RVS RECREATIONAL
VEHICLE
SERVICES, INC.

March 6, 1989

ALIGNMENT INSTRUCTIONS FOR FMC MOTORHOMES # 1-70-646

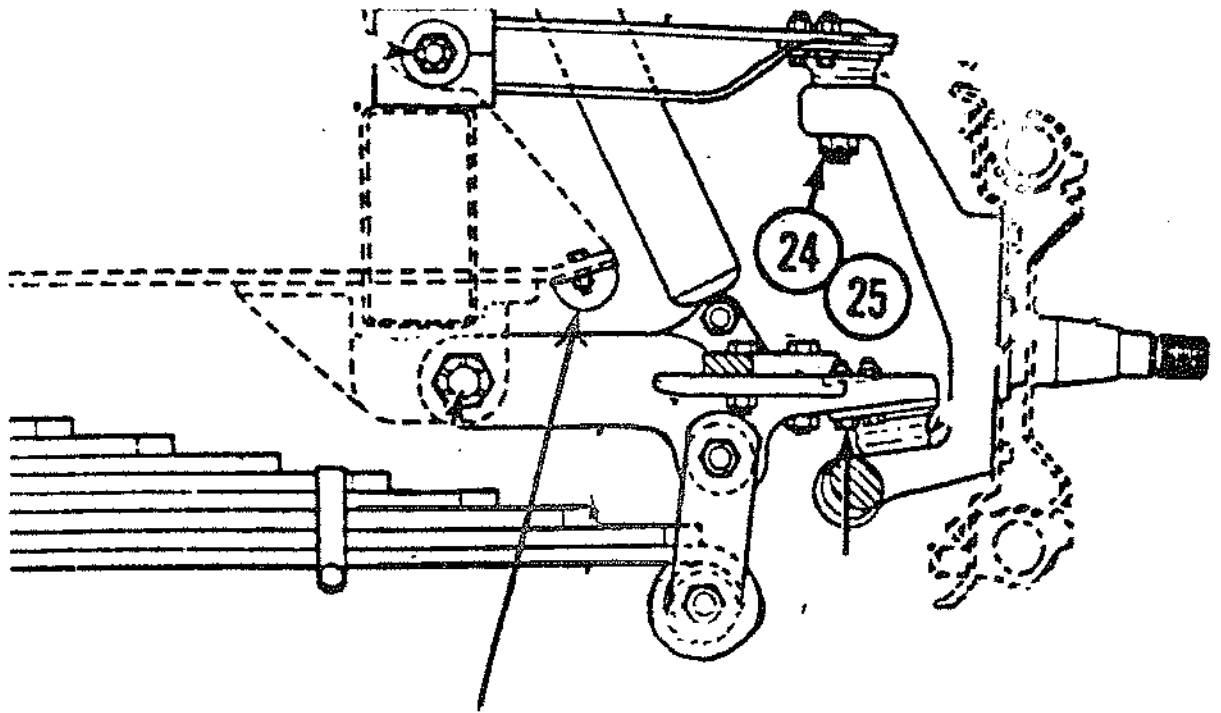
1. Drive vehicle FMC with domestic water tank full. Park on a level surface.
2. Level front to rear and side to side by adjustment of rear torsion bars, rear 1/8" low.
3. Using "John Bean" tool attached (magnetically) to front spindle/hub cover plate set caster at ~~3~~ ^{TO 4°} degrees + or - 1/2° positive adjusting lower support tube between chassis frame and lower suspension arm.
4. Set camber 1/8 degree negative by revolving cam adjusters on top "A" arm pivot shaft. Be sure to tighten bolts through pillow block cap after adjustment.
5. Re check caster. If further adjustment necessary recheck camber.

Note: when adjusting camber rotate cam adjusters equally or a broken A-Arm pivot shaft may result from the binding of the cam adjusters.

8. Locate idler so idler arm is parallel to chassis frame rail by adjusting center tie rod. Lock in place.
9. ~~MAY BE SET AT 0 TOE~~ ^{3+ PLACE} Set toe by adjustment of outboard tie rods to 1/8" total in (equal) 1/16" per side. You may check 0 toe by preliminary measuring from tire to outside of chassis frame before final adjustment.
